SERVICE BULLETIN

N° 139-613

ATA 95 - IMPROVEMENT OF EMERGENCY FLOATS RIGID COVER

IMPROVEMENT OF RIGID COVERS

Figure 6 : Interior of the rigid cover

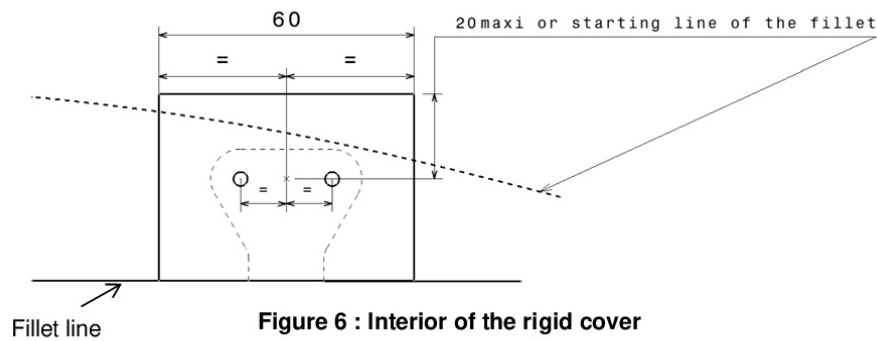
- (6) Check the hole diameter after removal of the rivet.
- c) Using a chisel, gently lift the container hinge.
2. Trace the contour of the area to be repaired using the center of the fixation points of the hinge as a reference, see Figure 6.

3. Using medium-grit sand paper, sand the area to be repaired on the interior of the rigid cover.
4. Using Acetone, clean the surface to be repaired.
5. Cut ply of glass fabric (60mm x 40 maxi). Adjust the shape and size of the glass fabric to correspond to the size of the sanded area.
6. Prepare the two-component resin as per packaging instructions.
7. Apply the mix of resin on the sanded area.
8. Apply the glass fabric.
9. Apply another layer of resin over the glass fabric making sure the glass fiber is completely covered
10. Cover with a vacuum film to obtain a smooth surface.
11. Clamp to maintain the position.

Figure 7 : L/H FWD rigid cover exterior view for drain hole positioning

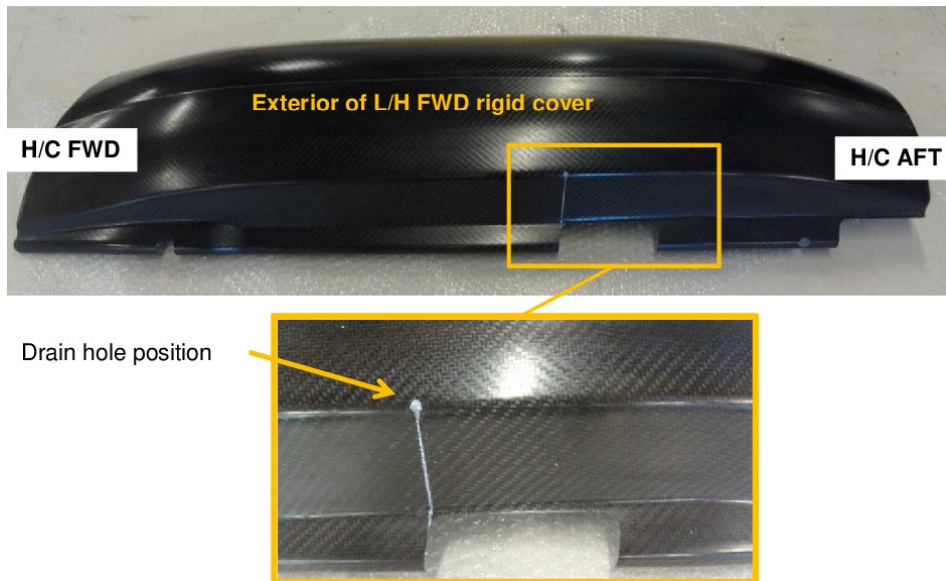
1. Drill a 6 mm hole in the left FWD rigid cover. Looking at the cover as shown in Figure 7, the centre of hole shall be aligned with the left edge cut of the large bottom foot step opening of the left rigid cover and the centre of the fillet center, see Figure 7, 8 & 9 for drain hole positioning illustration. When installed on the helicopter, the hole shall be in the lowest part of fwd rigid cover.

Figure 9 : L/H FWD rigid cover exterior view and drain hole detail, drawing extract

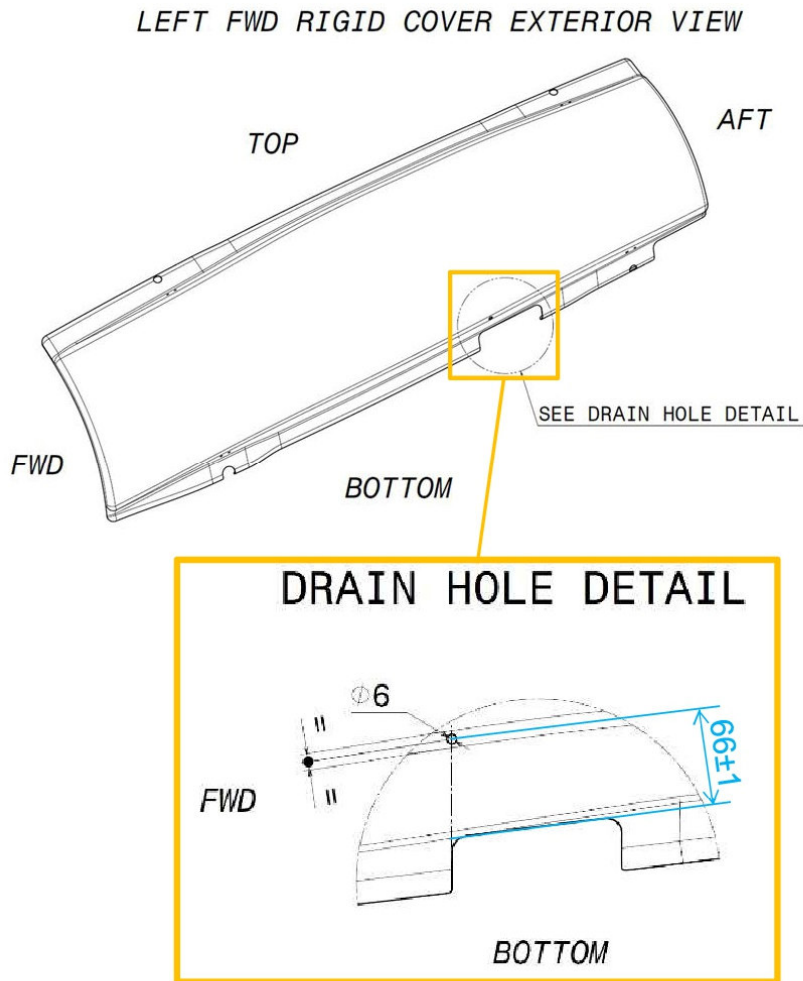
2. Drill the right FWD rigid cover symmetrically to the left FWD rigid cover.

Figure 10 : L/H AFT rigid cover exterior view for drain hole positioning

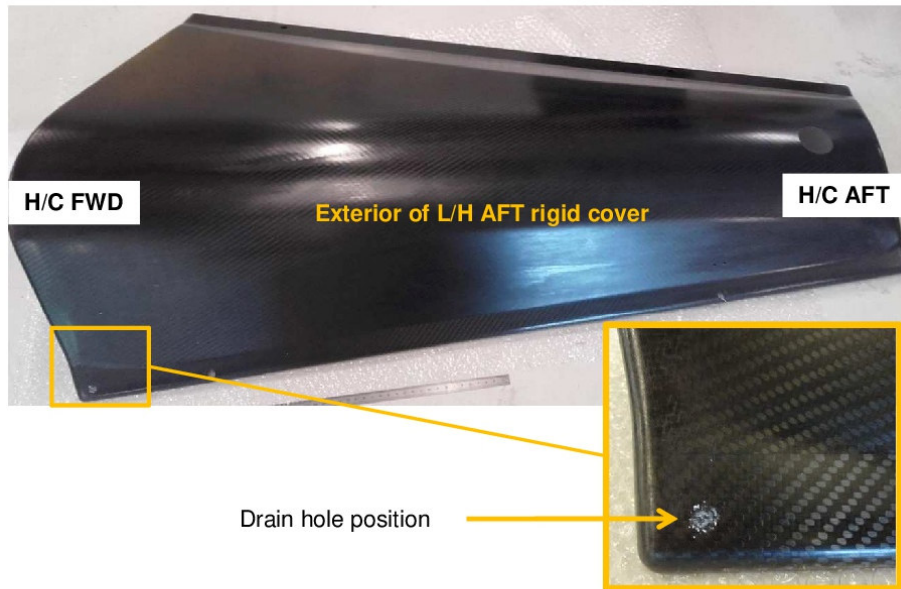
3. Drill a 6mm hole in the left AFT rigid cover. Looking at the cover as shown in Figure 11, the centre of the hole shall be at 35 mm of the H/C FWD side of the cover edge and 15 mm of the bottom side of the cover edge, see figure 10, 11 & 12 drain hole positioning illustration. When installed on the helicopter, the hole shall be in the lowest part of aft rigid cover.

Figure 12 : L/H AFT rigid cover exterior view and drain hole detail, drawing extract

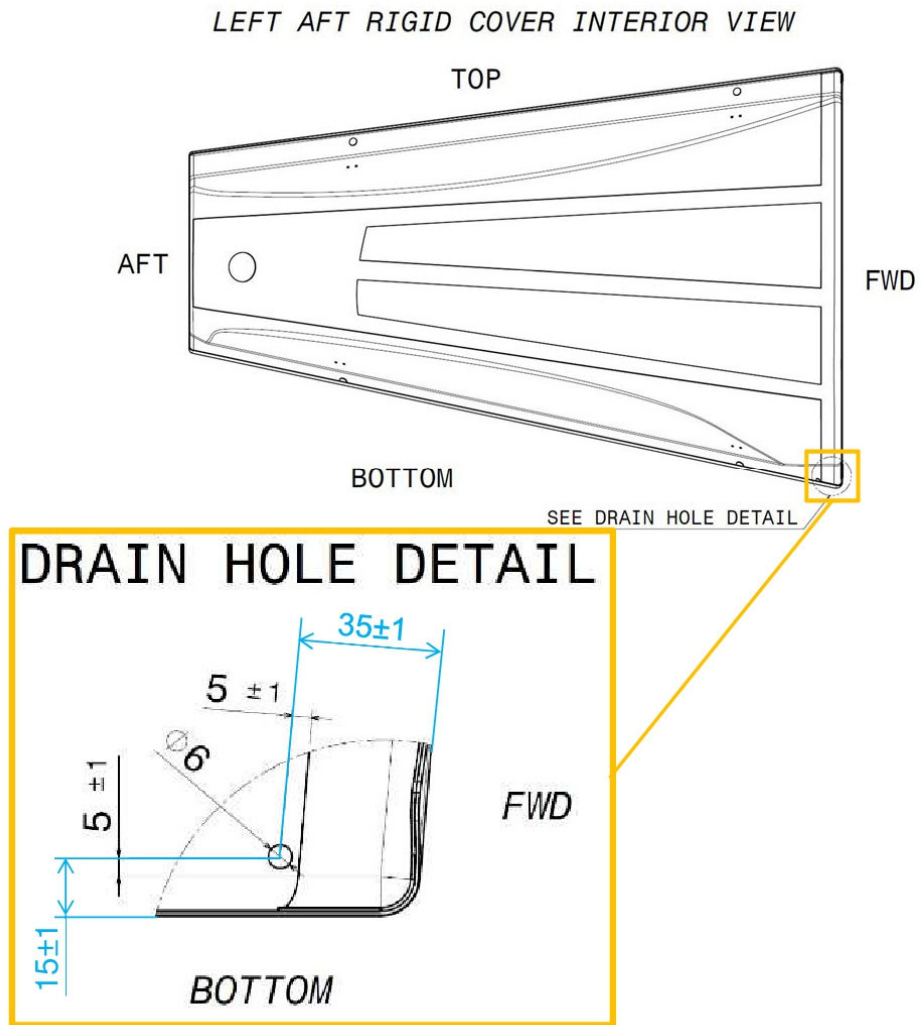
4. Drill the right AFT rigid cover symmetrically to the left AFT rigid cover.

Figure 13

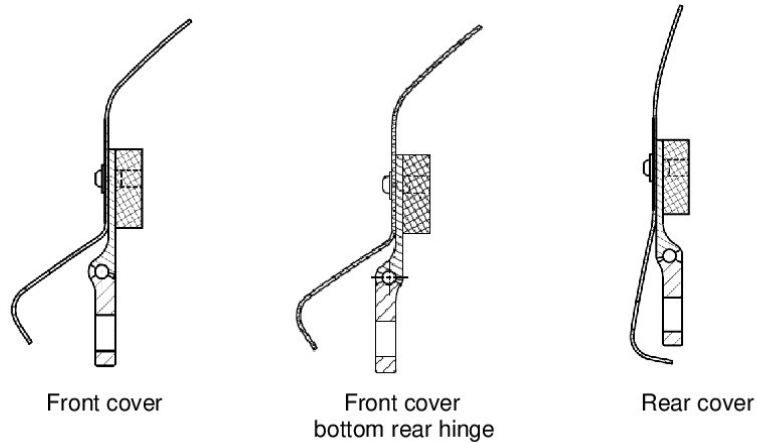
1. Place the hinge on the container.
2. Insert the two rivets coated with sealing compound through the hinge.
3. Insert the washer with sealing compound applied on the side in contact with the container side, on the bulb side of the rivet, see Figure 13.

Figure 14

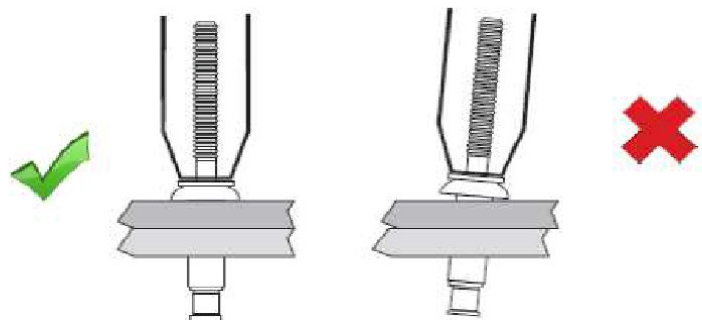
NOTA : Make sure to maintain the rivet perpendicular to the surface of the part during the riveting phase, see Figure 14.

Figure 15

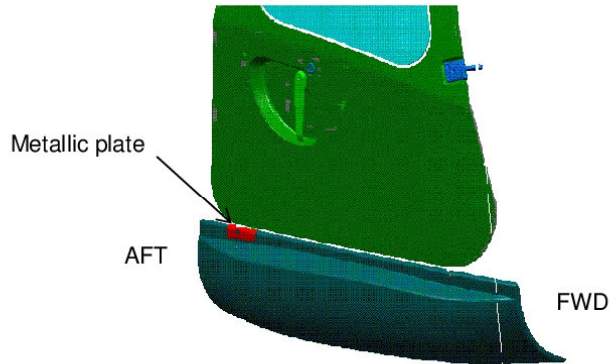
1. Roughly trace the position of the protective plate
2. Remove any primer and paint applied on the cover in order to properly prepare the surface for metallic bonding.
3. Put the metallic plate over the top AFT hinge of the rigid cover (see Figure 15).

Figure 16

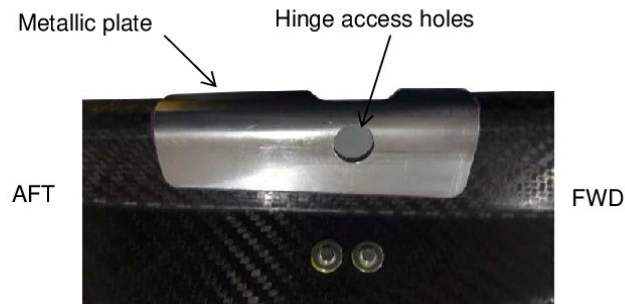
4. Align the hinge access hole of the metallic plate with the one of the rigid cover (see Figure 16).
